**Cockle Bay Park Landbridge over the
Western Distributor**

Landbridge Design Principles

21 September 2017

Revision: 2

Future RMS Projects and Structural Zones

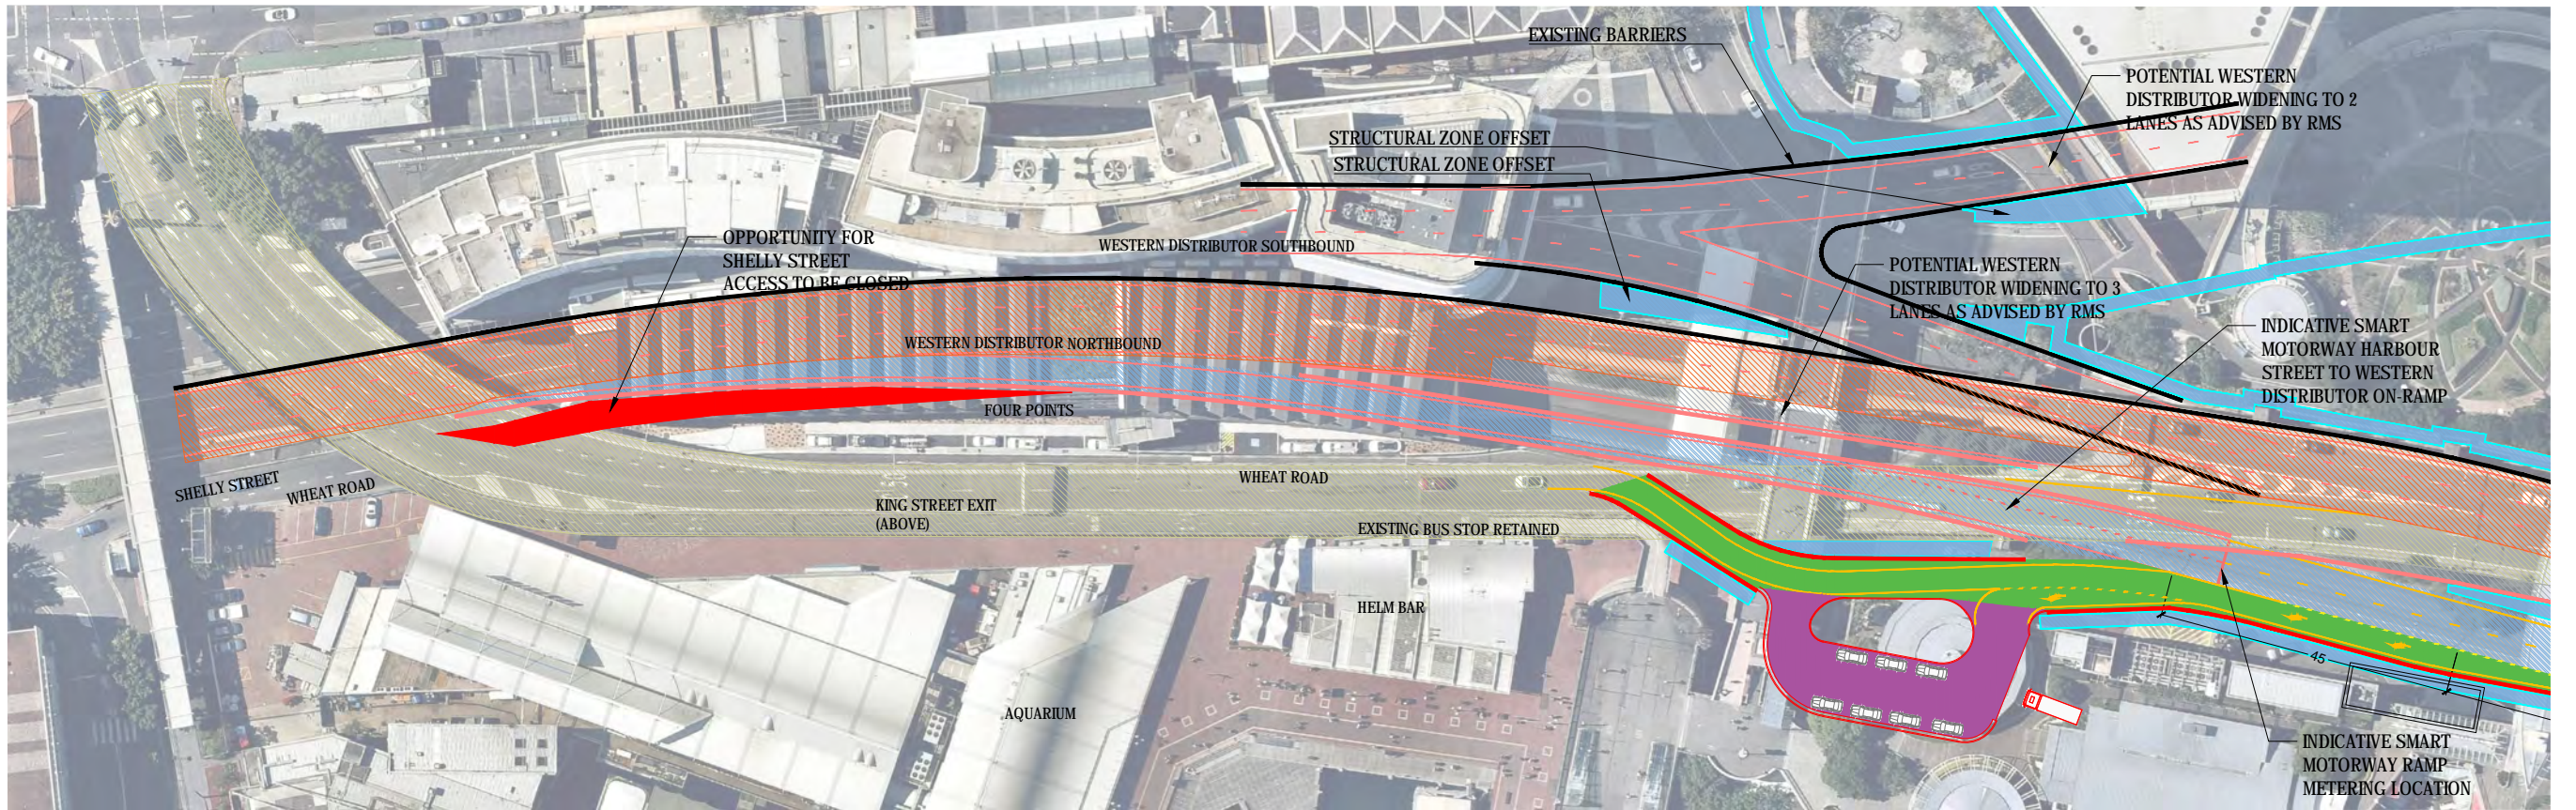
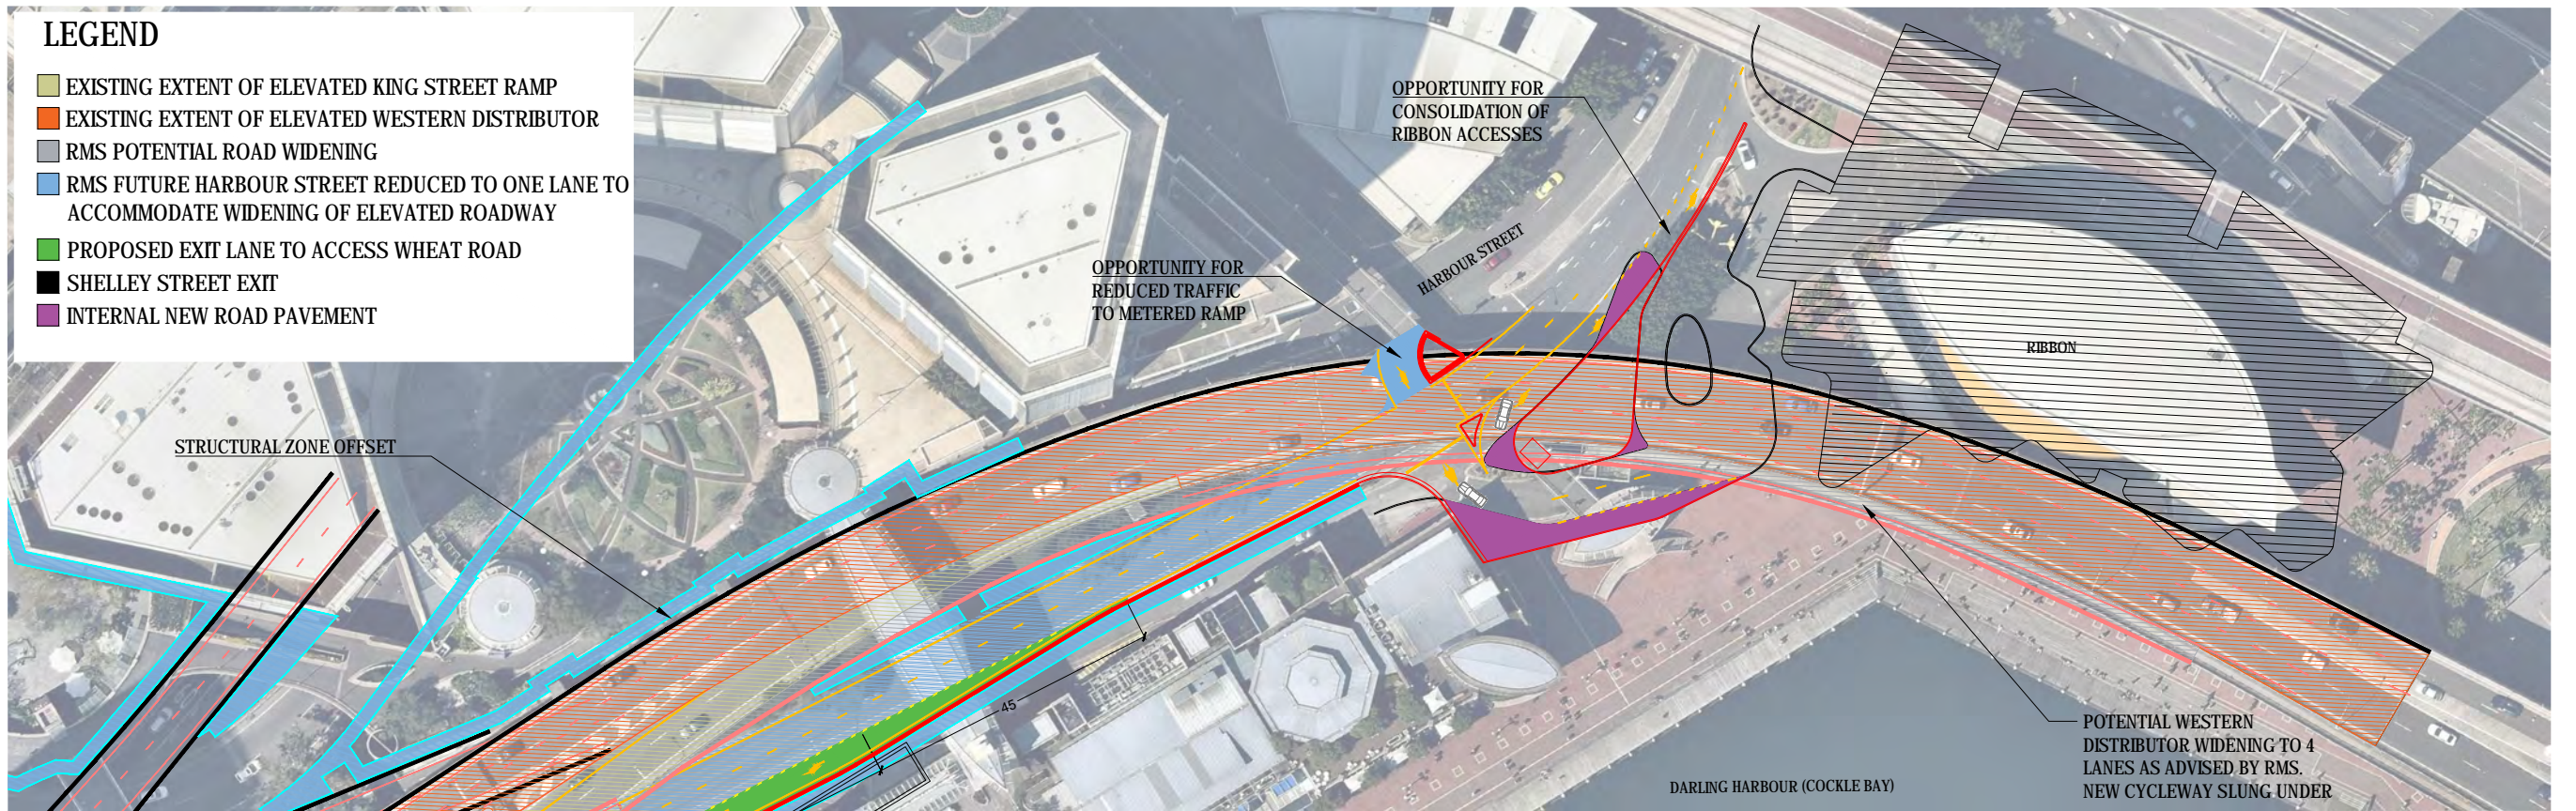
- d) **Piering Options** – Roads and Maritime has asked the proponent to identify where the piers for the Podium are to be located in relation to the Western Distributor. Roads and Maritime has requested a "no piers" in addition to the proposed "piers" option be investigated and considered. The location of the piers for the Podium in relation to the Western Distributor is required to enable the practical consideration of matters relating to structural integrity, accessibility, safety, security and maintenance, repair, augmentation and replacement. The development application should not be determined until this information has been provided and addressed to Roads and Maritime satisfaction.

The piers have been positioned on the basis of the drawing included in Appendix D. This drawing indicates the available structural zones, informally agreed with RMS, that have been determined in conjunction with the existing road network and potential RMS projects for future road corridors. Once construction is complete, these locations will be outside the road barriers.

**COCKLE BAY PARK
INTENT OF CLEARANCE TO ELEVATED WESTERN DISTRIBUTOR
STRUCTURE**

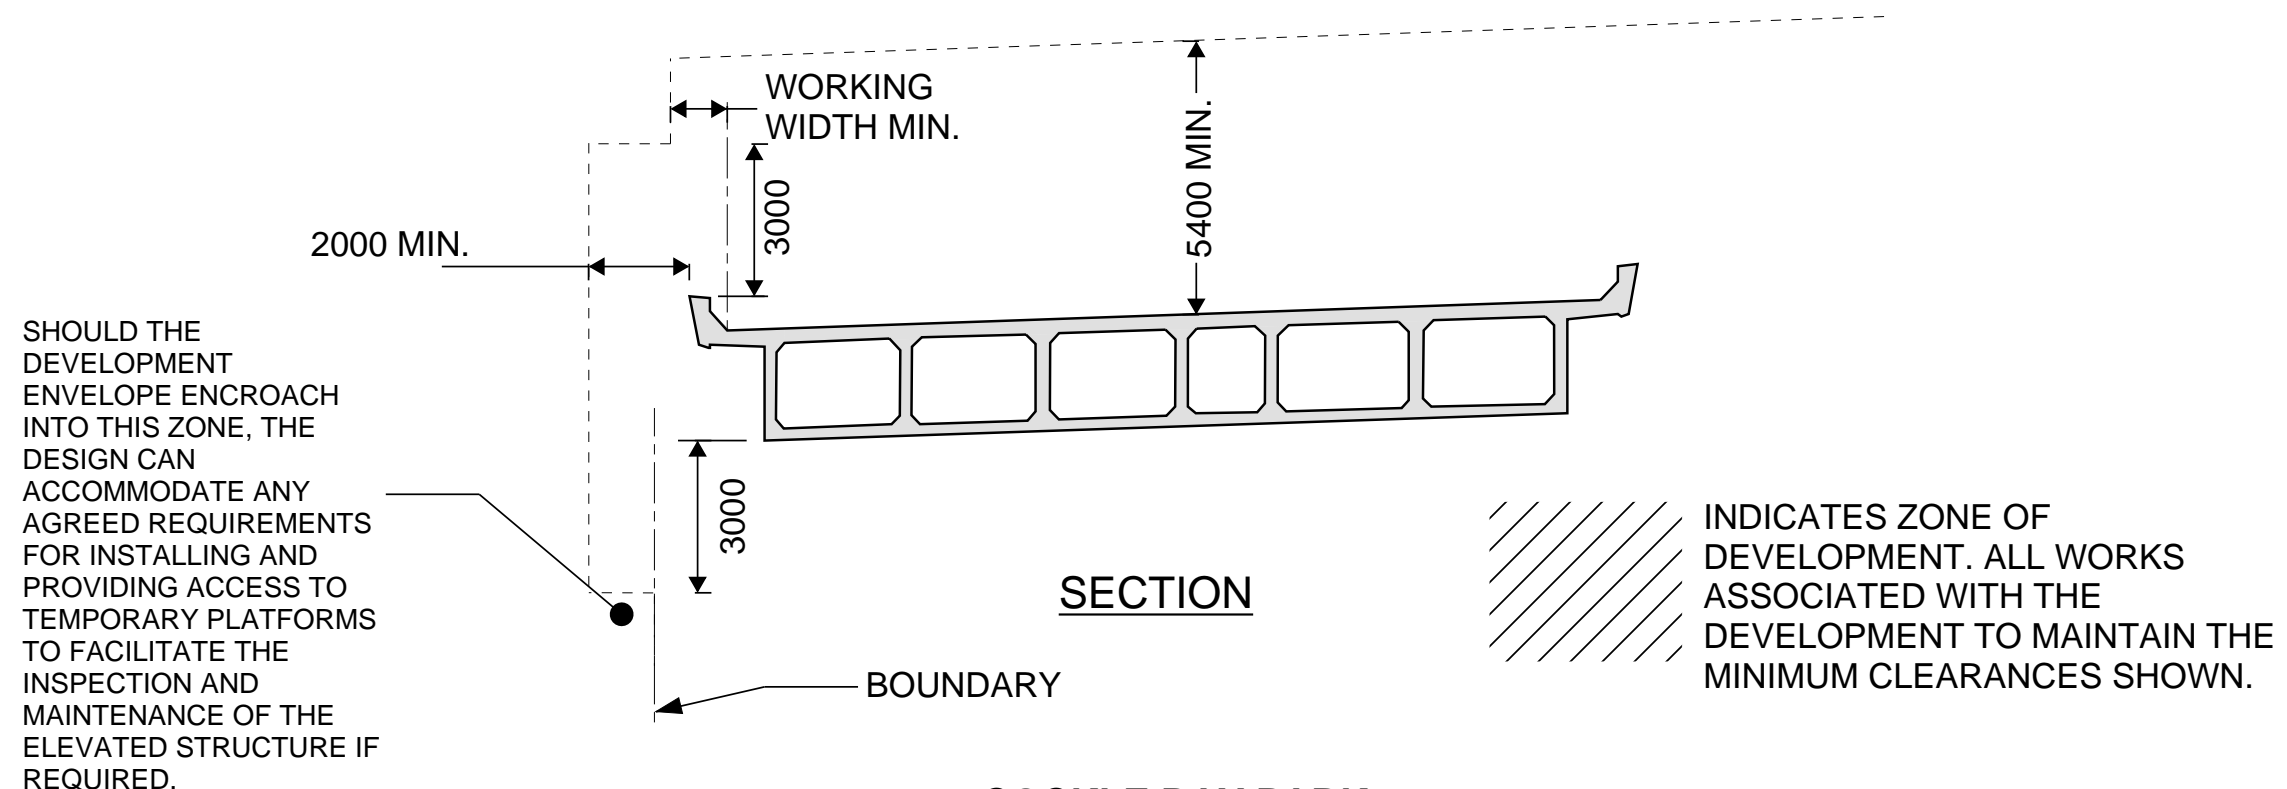
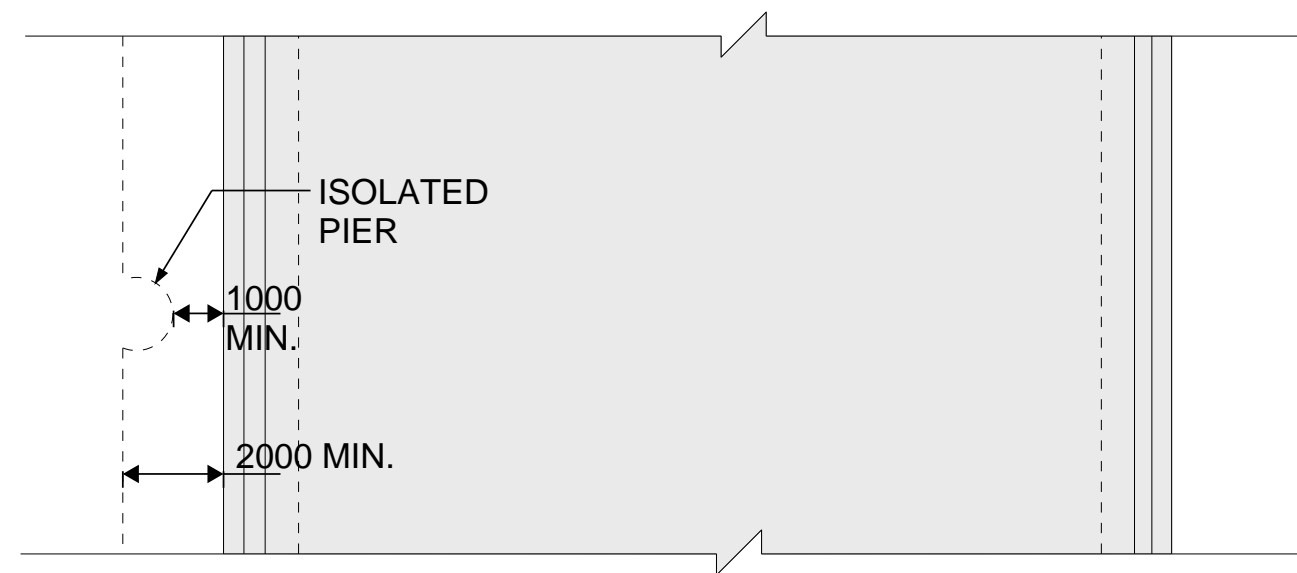
- e) **Access for Maintenance and Repair** – the proponent will need to be able to demonstrate to Roads and Maritime satisfaction that the Podium will not unreasonably interfere with Roads and Maritime ongoing ability to access the Western Distributor and its surrounds for the purposes of maintenance, repair, augmentation and, if necessary, replacement of the Western Distributor.

- In consultation with RMS, the intent of clearance to the elevated Western Distributor has been developed and is presented in Appendix E of this report. These minimum clearances will enable the inspection and maintenance requirements of the road network to be carried out to the same degree that they are currently undertaken.

THE INTENDED CLEARANCES SHOWN IN THIS DIAGRAM HAVE BEEN PROPOSED FOLLOWING COORDINATION WITH RMS REGARDING THE ACCESS REQUIREMENTS TO INSPECT AND MAINTAIN THE ELEVATED WESTERN DISTRIBUTOR STRUCTURE. WITH THESE CLEARANCES, THERE IS NOT EXPECTED TO BE ANY SIGNIFICANT CHANGE TO THE ABILITY TO SAFELY ACCESS AND MAINTAIN THE ROAD NETWORK AS A RESULT OF THE PROPOSED LANDBRIDGE.

Preliminary Construction Programme

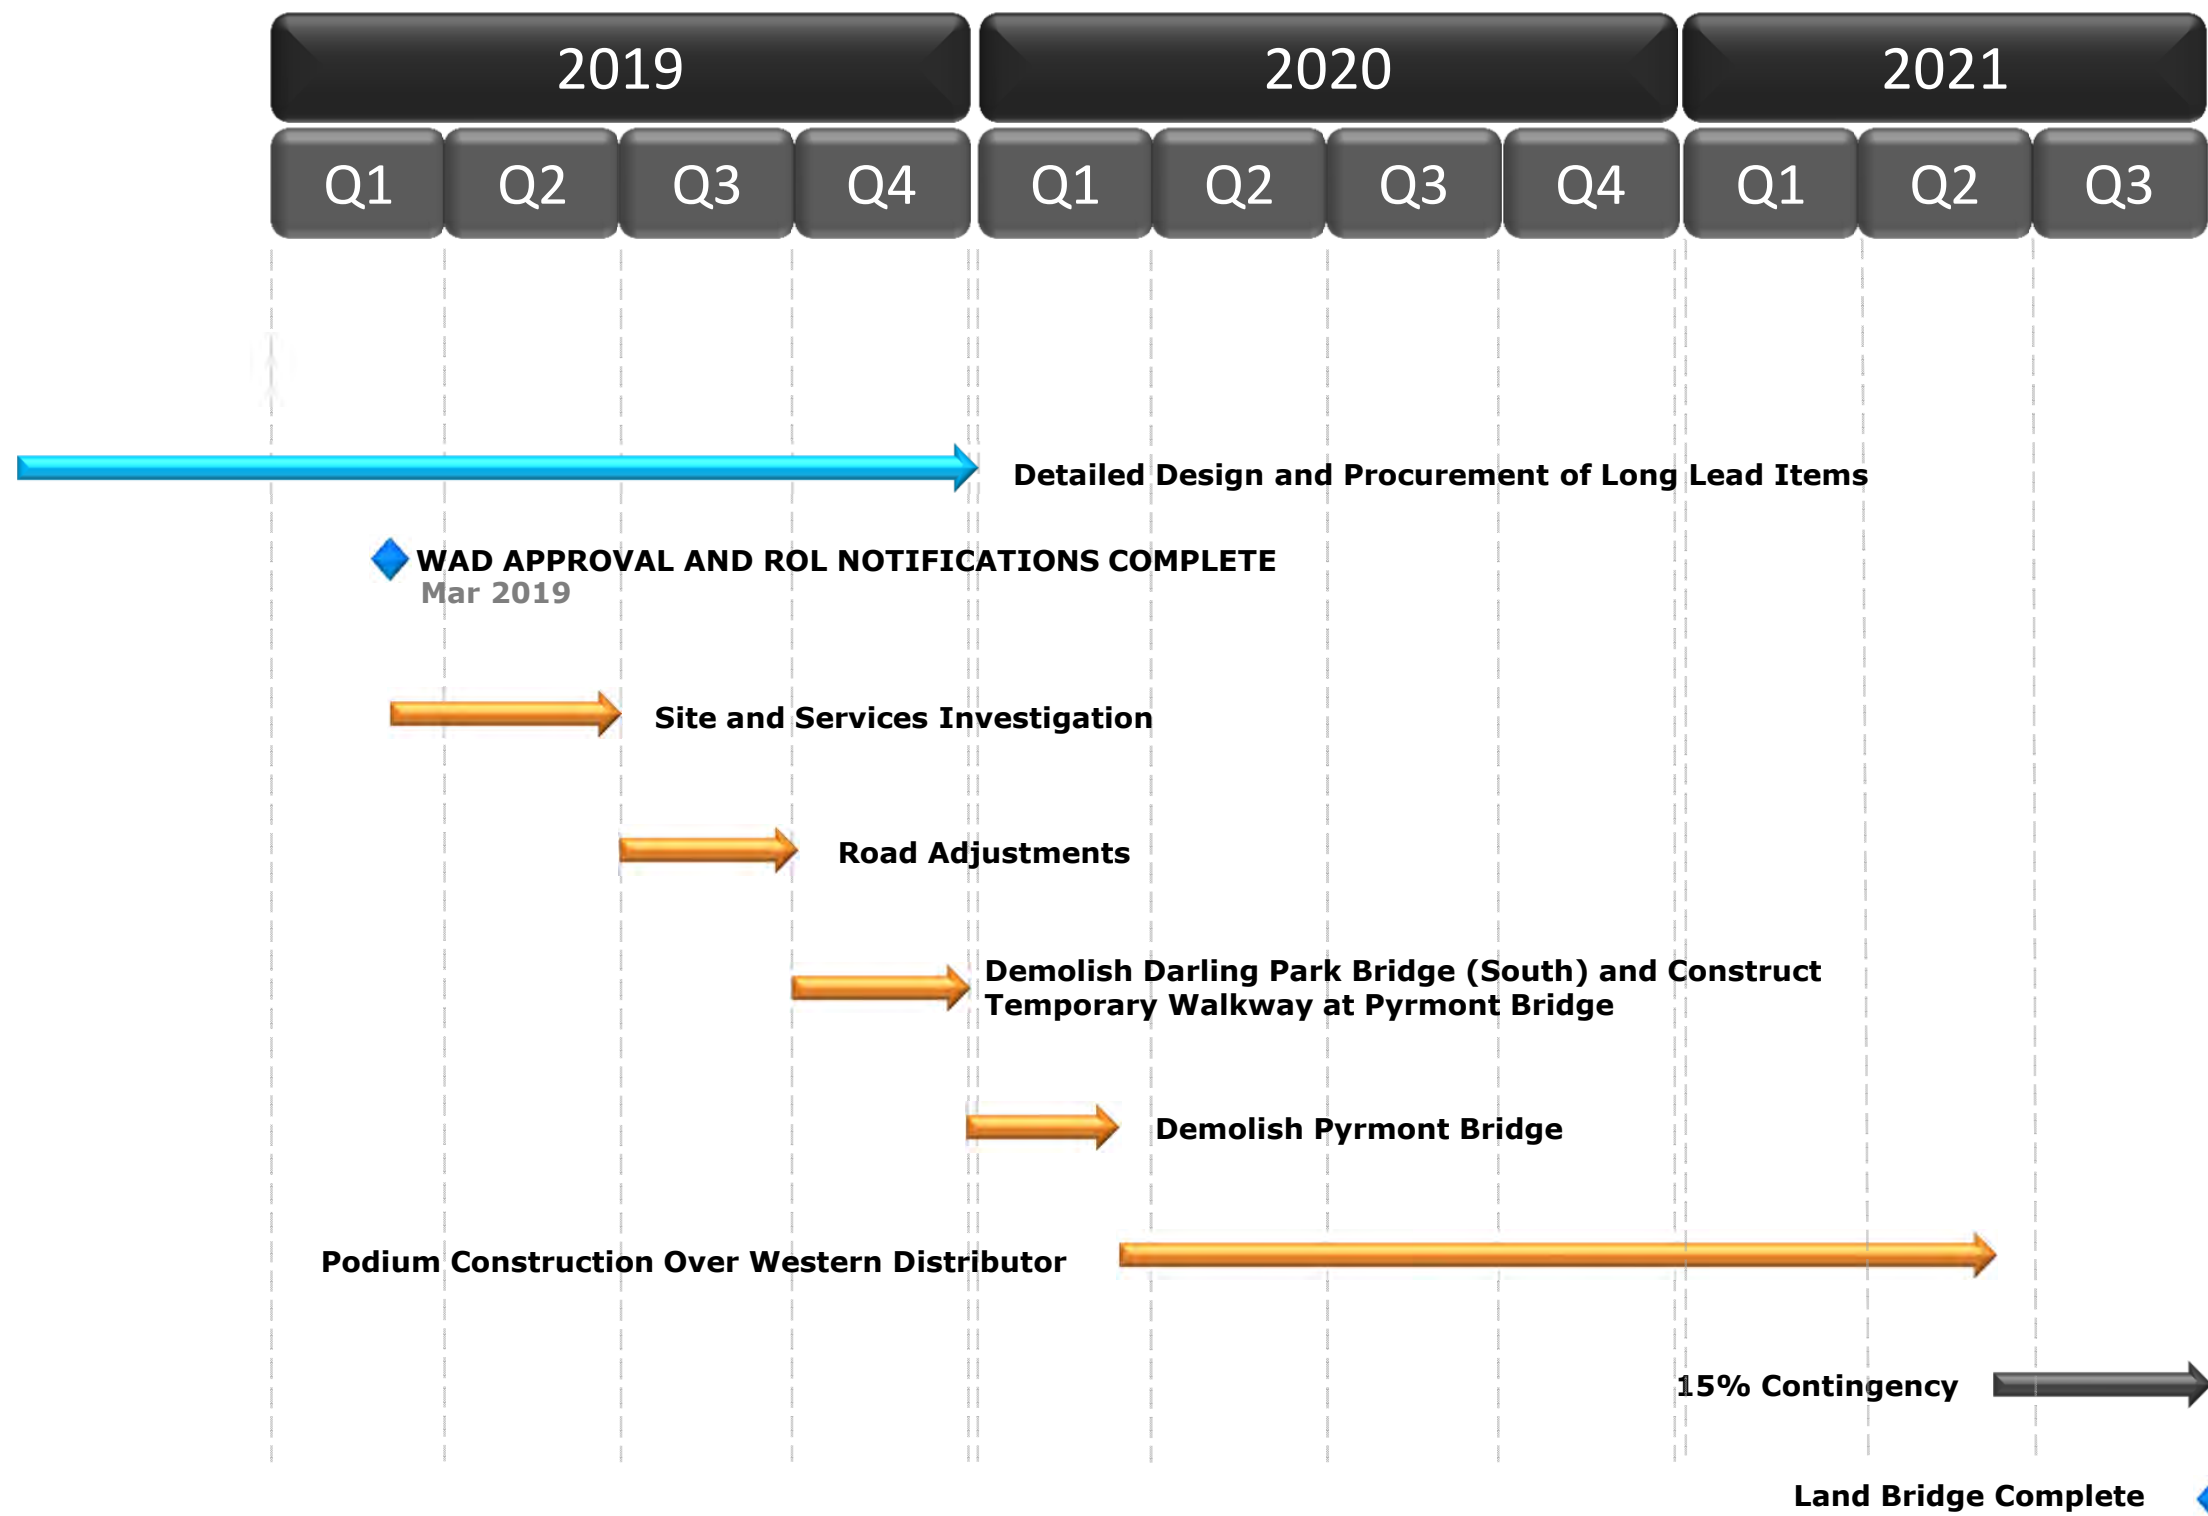
- h) **Constructability** – the proponent will need to be able to provide details of the methodology of how the Podium is to be constructed over the Western Distributor to ensure the above issues are addressed.

Construction of the landbridge will require access to the Western Distributor for construction and materials handling. Some closures of the Western Distributor will be necessary. A preliminary programme has been included in Appendix I.

Construction planning has been developed to minimise closures of the Western Distributor. Pier and column locations have been located and can be constructed with minimal lane closures.
